RE: SUBMISSION TO SSD-78669234, Residential flat building with in-fill affordable housing
Address: 27-29 Tryon Road, Lindfield

ATTACHMENT 1

Ku-ring-gai Council's objection to SSD-78669234, Residential flat building with in-fill affordable housing at 27-29 Tryon Road, Lindfield

Figure 1 The proposed development results in an inappropriate height transition between the adjacent lower buildings

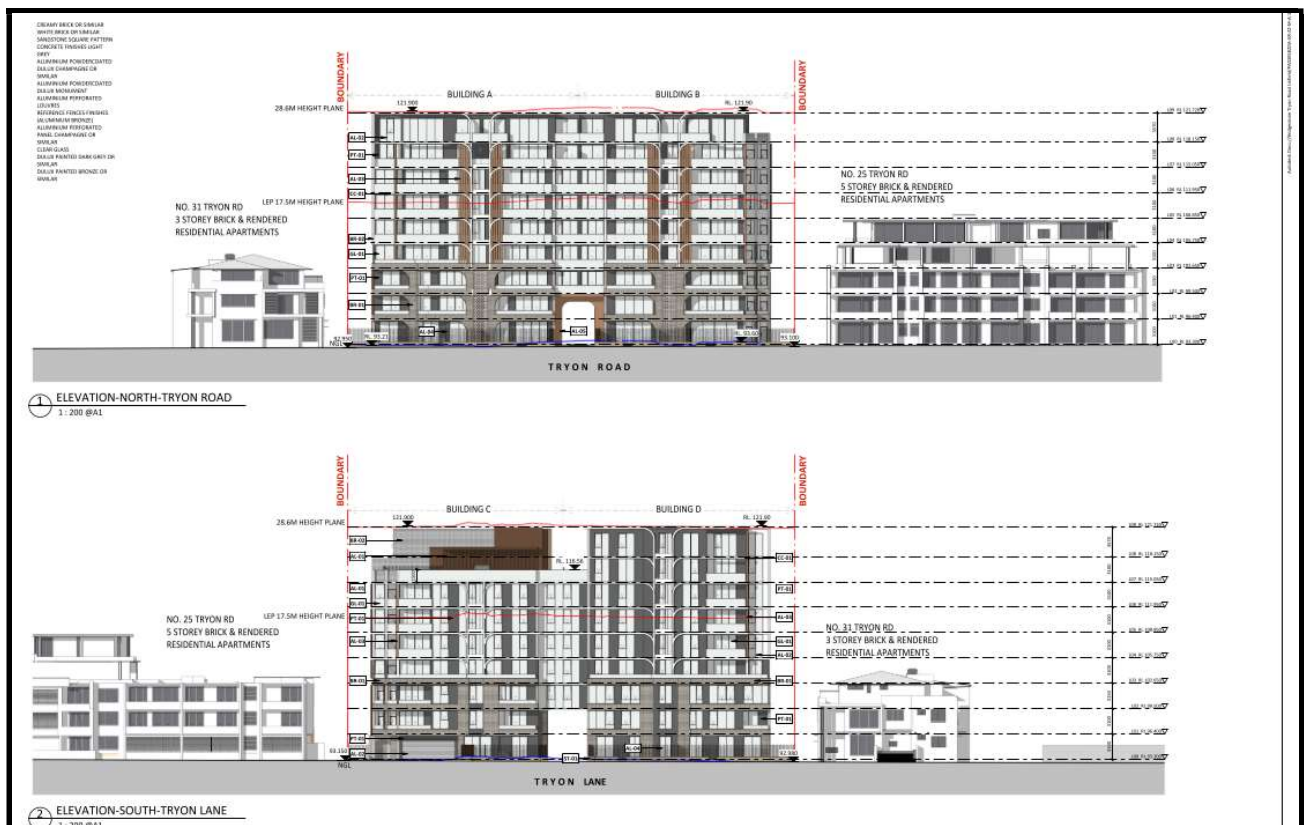
The proposed massing of the RFB does not provide a well-considered visual transition between the development and the established buildings within the visual catchment of the site. Although a portion of the south-western façade of Building B is partially stepped in, it does not sufficiently mitigate the height difference, leading to dominant, abrupt and overwhelming bulk and scale impacts on neighbouring properties (**Figure 1**). Moreover, when viewed from the public domain, the development fails to establish a harmonious relationship which respects the existing local context while balancing the desired future character of the street and surrounding buildings through appropriate heights and built form, as outlined in Schedule 9 of the SEPP.

Significant design changes are recommended to ensure the proposal integrates into Ku-ring-gai's established character. Modifications should resolve issues relating to bulk and scale impacts to adjacent development of lower height and density as well as neighbouring heritage properties.

The front setback of the proposed 9 storey building should reflect and reinforce the character of the streetscape and provide sufficient space for the planting of substantial canopy trees. The front setback of Building A should be increased so that it is not less than the front setback of the adjoining 3 storey RFB.

Figure 2 inadequate privacy measures between central balconies and habitable rooms of Buildings A and B (plan view)

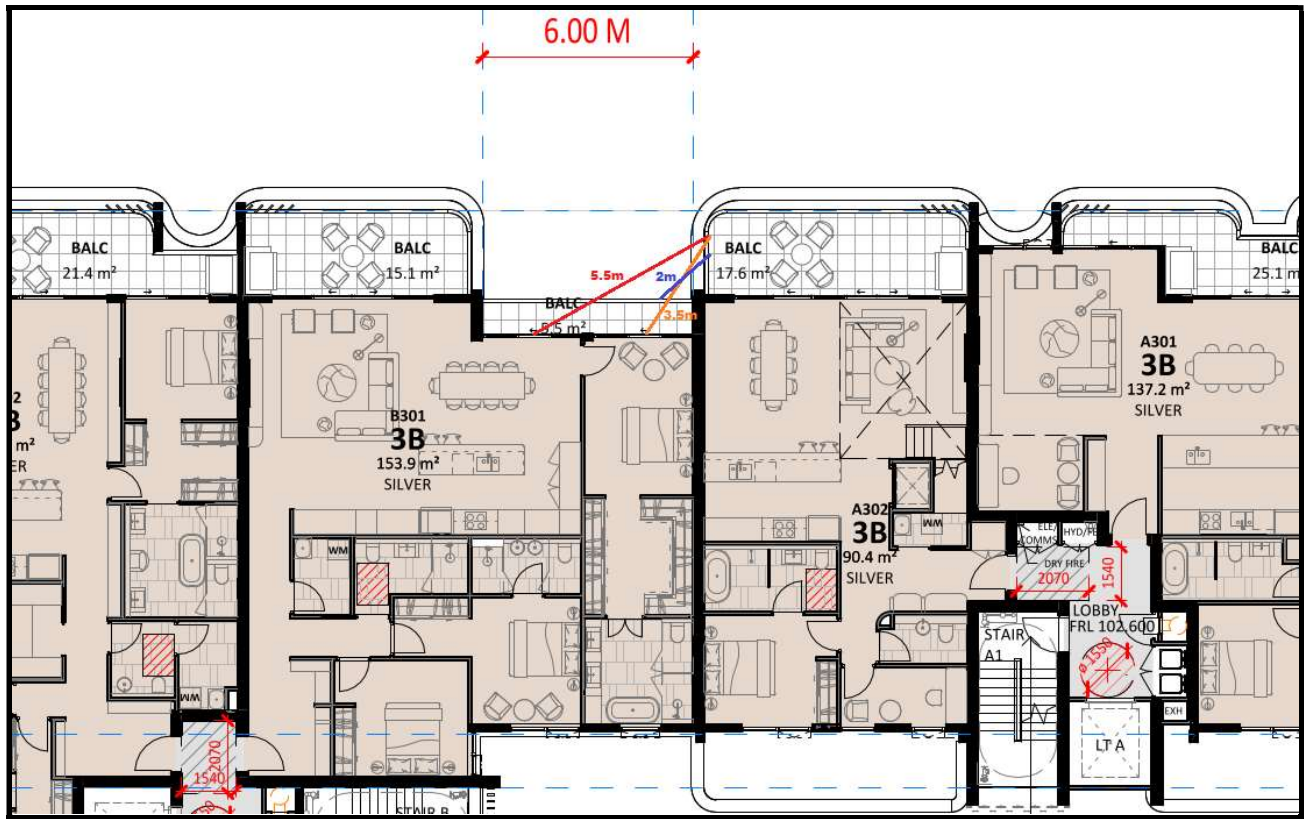
Most of the central balconies of Buildings A and B have a separation distance of approximately 3.5m from bedroom windows, 5.5m from adjoining living rooms and 2m from balconies of the adjacent apartments. The inadequate separation coupled with the lack of privacy measures results in adverse overlooking and amenity impacts to the habitable rooms of the adjacent apartments (**Figures 2 & 3**).

Figure 4 inadequate privacy measures between adjoining balconies of Buildings C and D (plan view)

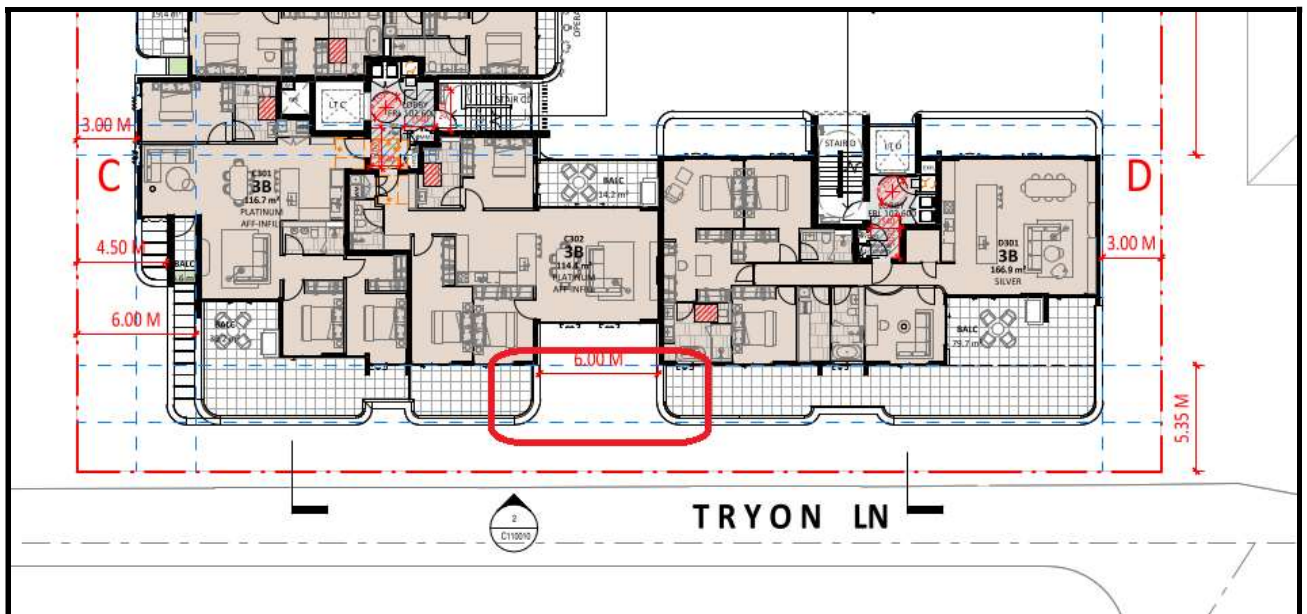
The balcony design from Level 2 to Level 7 of Buildings C and D detail non-compliant separation of 6m, when 9 to 12m is required (ADG 3F-1 1). No privacy measures have been incorporated into the design, allowing direct overlooking. (Figures 4 & 5).

Figure 6 Significant adverse overshadowing of neighbouring properties as a result of the proposal

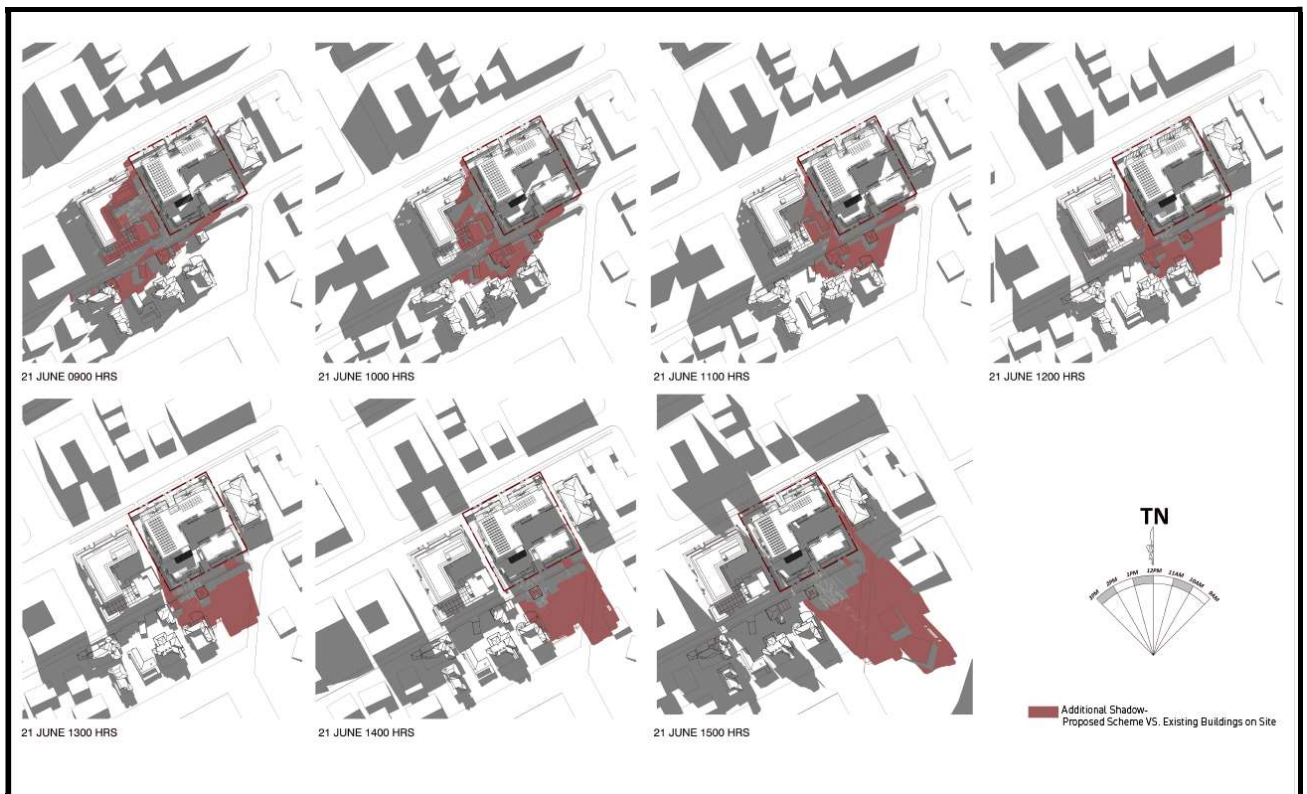
The 'Solar Access Sun-eye Diagrams' provided [DA-Q14A120A to DA-Q14A126] show that the proposal will severely overshadow the private open space and swimming pool of the existing dwelling at No. 24 Russell Avenue. This does not meet the requirements of ADG 3B-2 1, ADG 3B-2 2, ADG 3B-2 4 or ADG 3B-2 5. SEARs 7(dp1) requires that solar access impacts to the surrounding locality be assessed and that 'a high level of environmental amenity for any surrounding residential... land uses be demonstrated.' A high level of environmental amenity is not demonstrated through a severe and avoidable impact on solar access to No. 24 Russell Avenue.
